PMU Section Recommendation By Broadcom Corporation PMU Team

Broadcom								
	Company Confidential							
SIZE	TITLE							
В	BCM943907WLCSPR_	1						
DATE	13/04/2015:13:21	SHEET	7	OF	9

Figure 17: EMI Loops in Buck Switching Regulator

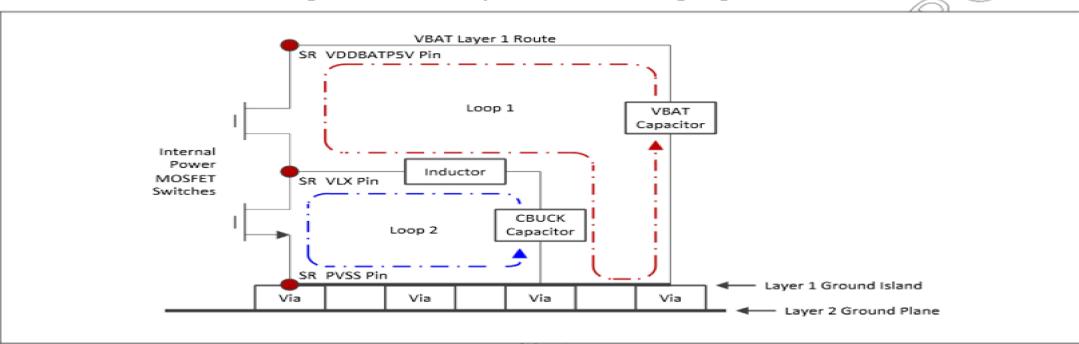
Picture Above Shows Two Loops through MOSFETs of CBUCK

- 1) Each loop starts from a cap and ends at its ground terminal.
- 2) The area within each loop is proportional to the EMI. Routing of sensitive signals through the areas
- 3)bounded by these two loops should be strictly avoided.
- 4)Top-layer routings are used to conduct switching currents to avoid micro-via inductances.
- 5) VBAT, CBUCK cap sits on a top-layer gnd island connecting to SR_PVSS pin directly.
- 6)Micro-vias are still used to connect this top-layer gnd island to 2nd-layer GND Plane and this only carries DC currents.
- 7)The 2nd Layer GND Plane also acts as a shield over the 2 EMI loops to prevent noise radiation to other layers.
